Product/Process Change Notice (PCN)

PCN_WS-TSW_base_20130314
Product Affected: WS-TSW 6*6mm
PN : 430 4xx 0xx 8x6

DETAIL OF CHANGE:

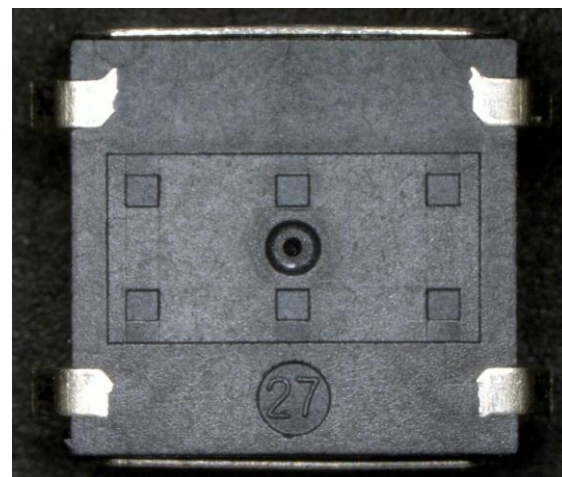
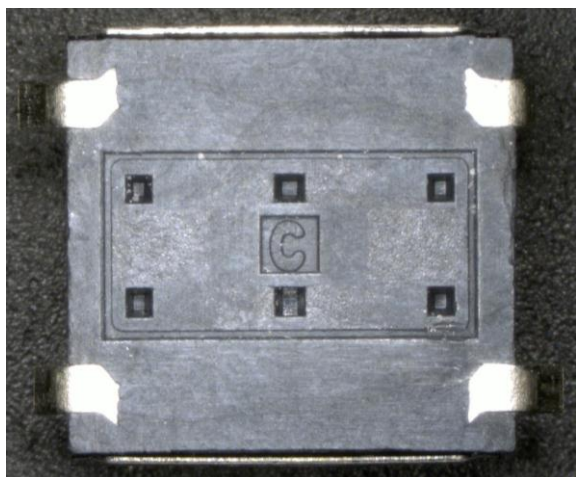
1. Purpose of change :
Product improvement. Injection mold upgrade from 2D(directions) to 3D(3 directions). The upgrade of the injection mold improves the internal polymer flow/merge.
2. Actions :
This does not influence Fit, Form and Function. The only small change is visual on the base, but it does not impact the total dimension.
3. Revise Specification
There is no specification change on the drawing or even on the electrical data's. From Visual, it's a minimum change.(See below pictures)
4. Cause this is a continuously improvement, therefore, we will not clean up our warehouse. Both versions can be send out to customer until the old version is complete sold out. New product is available after label date code :
01.July.2013
